RE: Phased Subdivision Application for 6719 Devon Avenue SE (AMANDA 20-118048-LD)

PW Completeness Review_Civil Plans_Devon Estates.pdf Markup Summary

P408

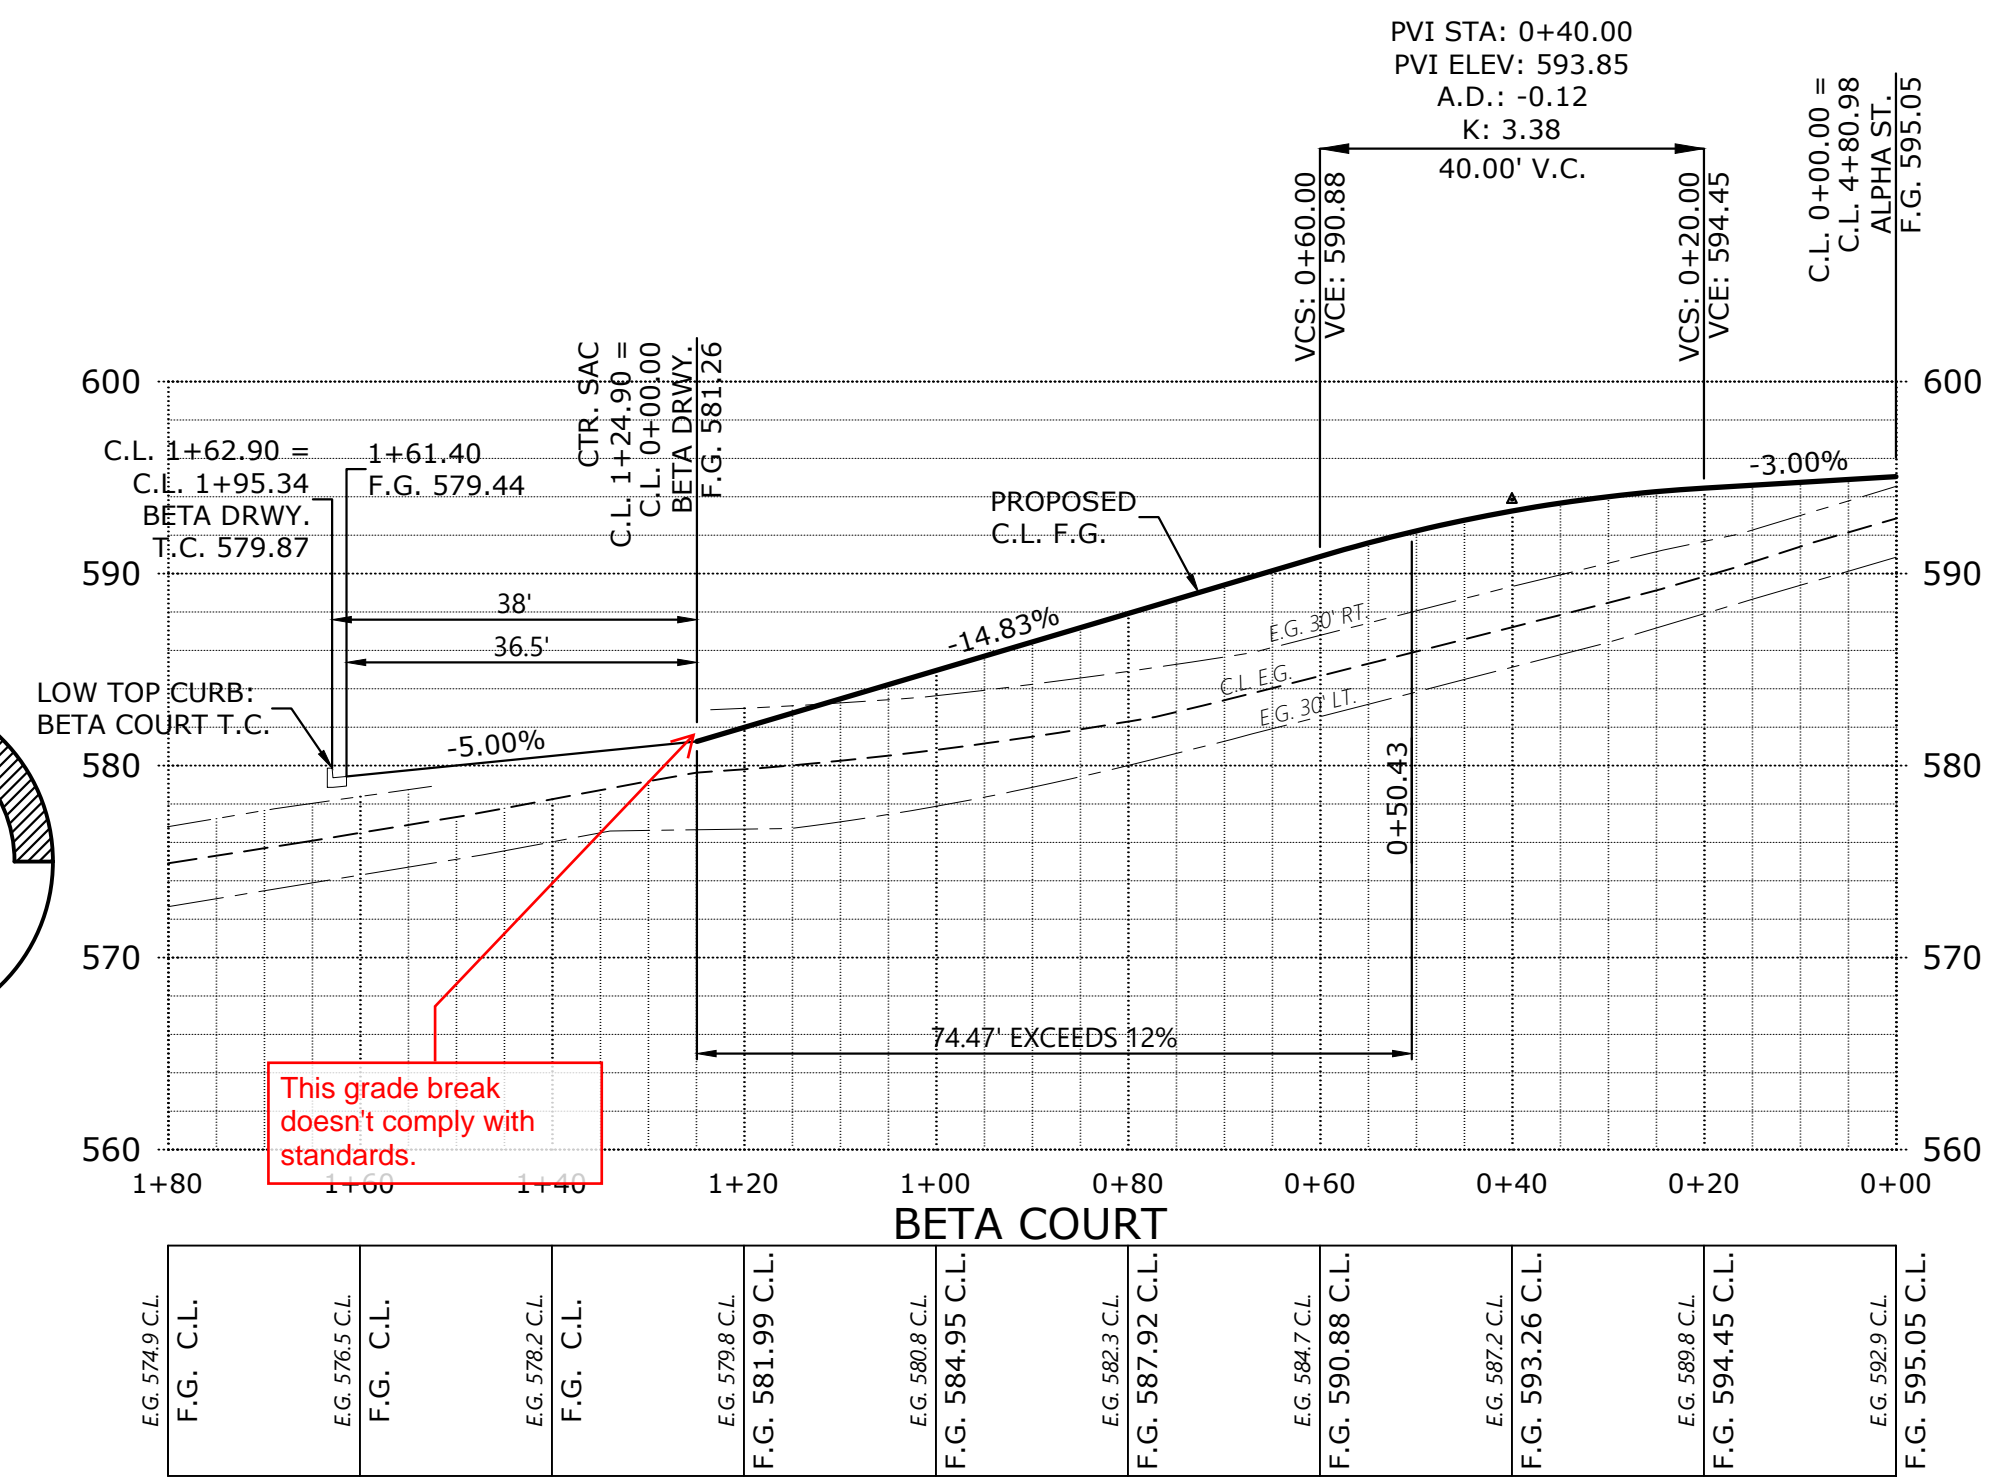
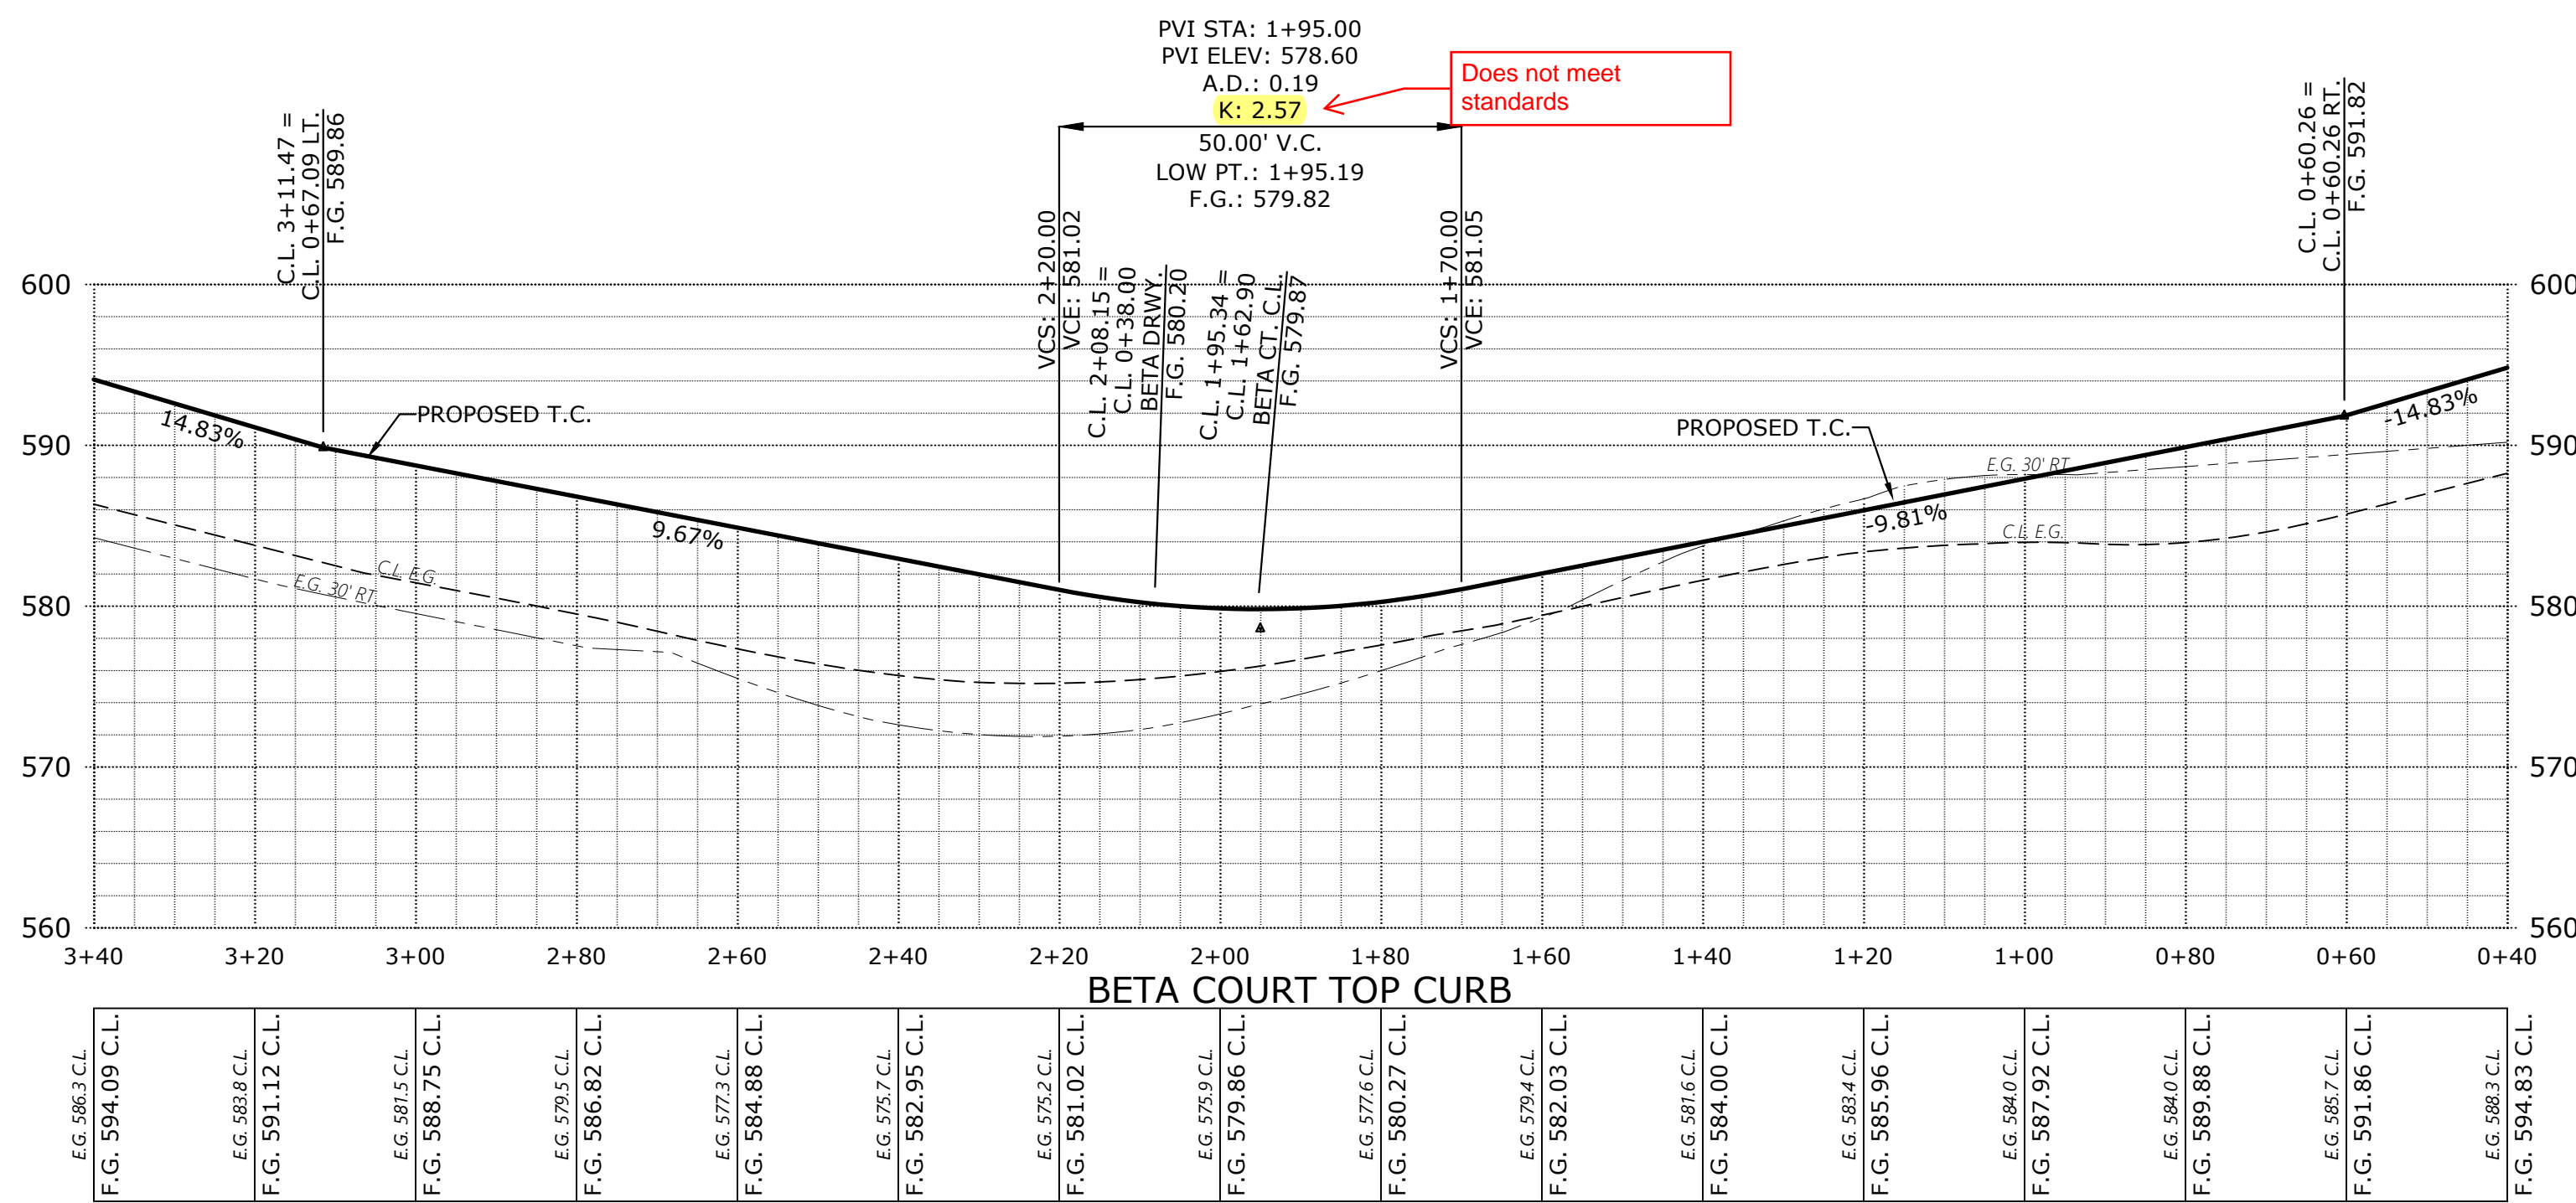
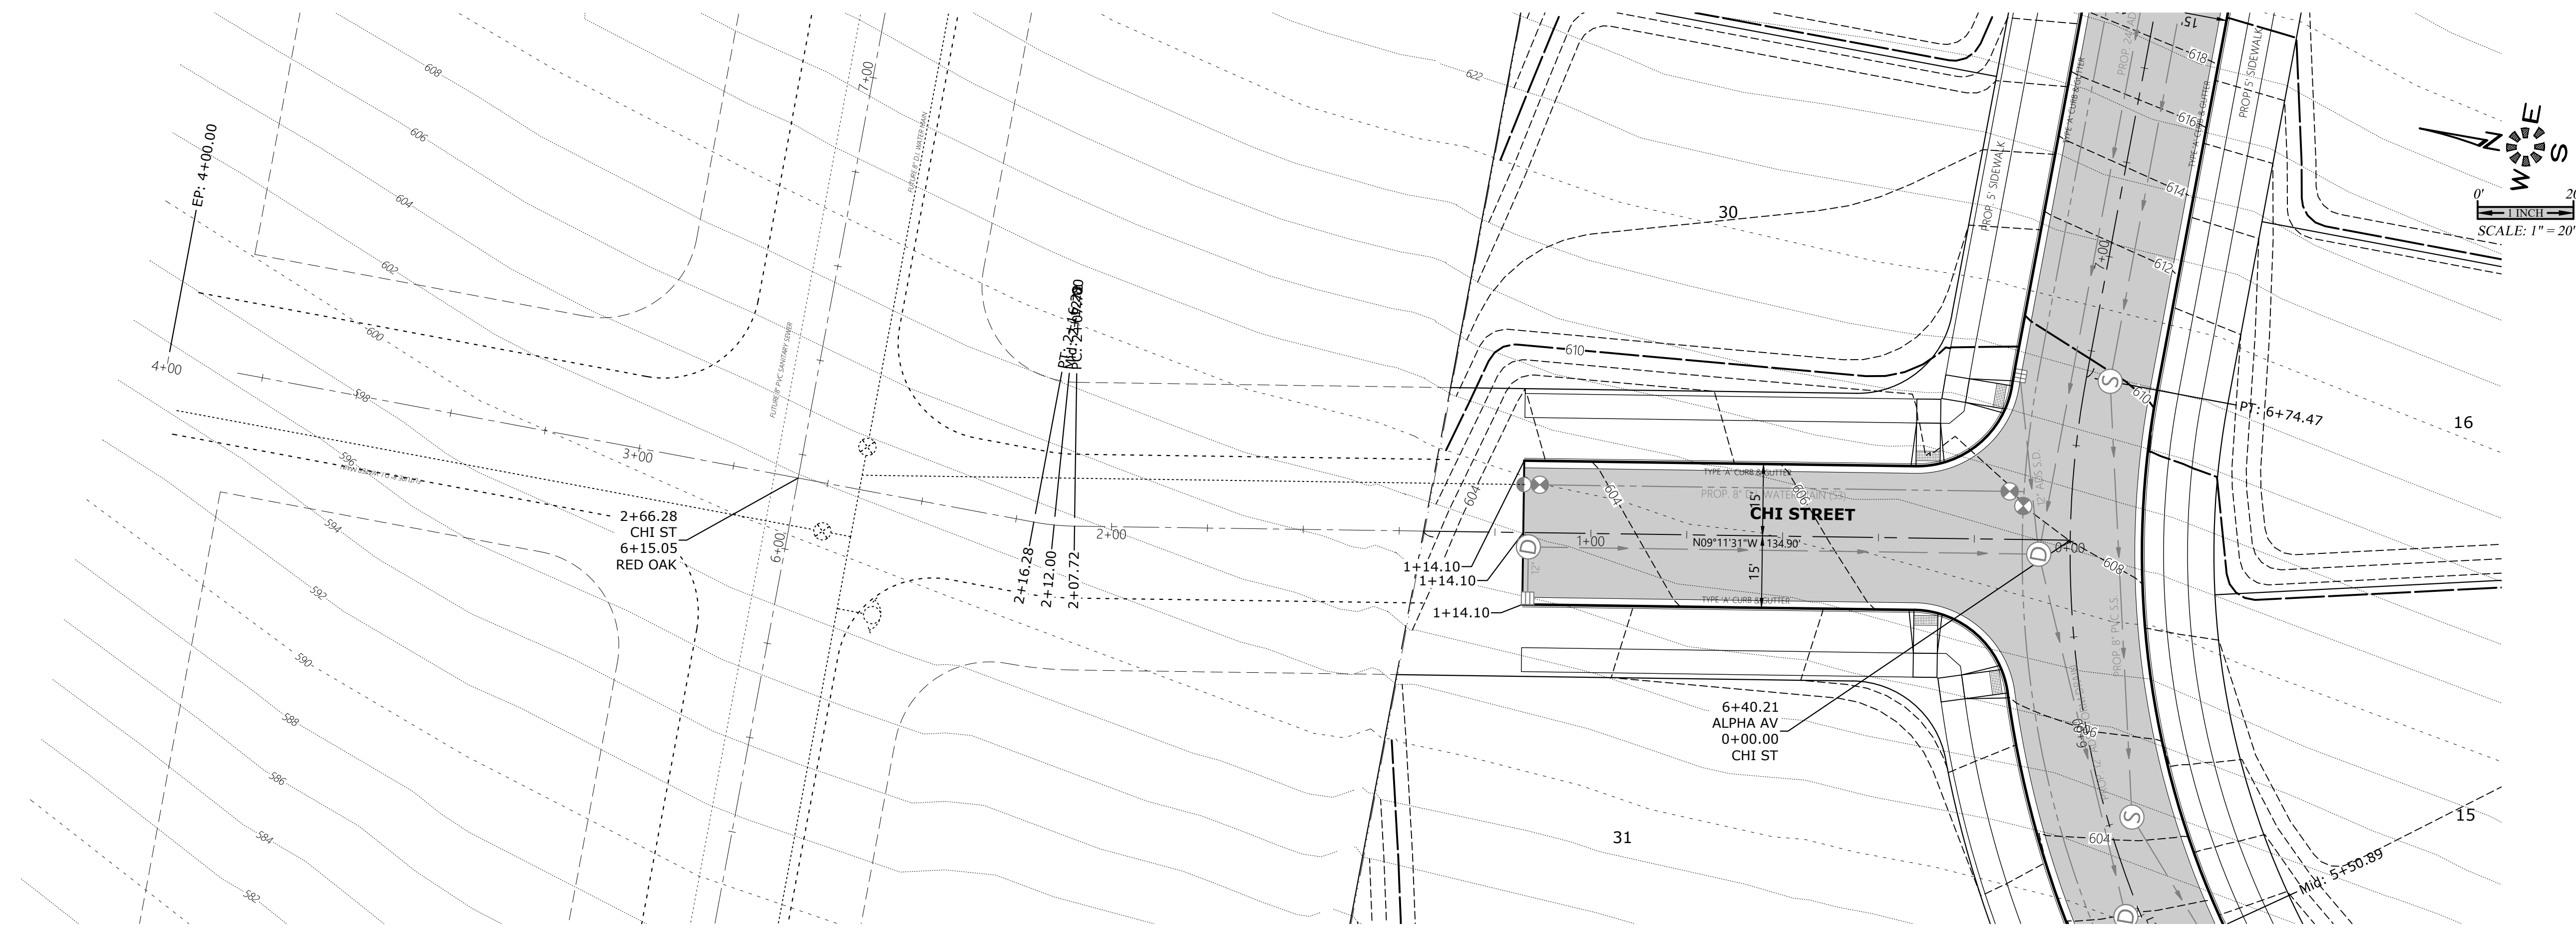
Does not meet standards

This grade break doesn't comply with standards.
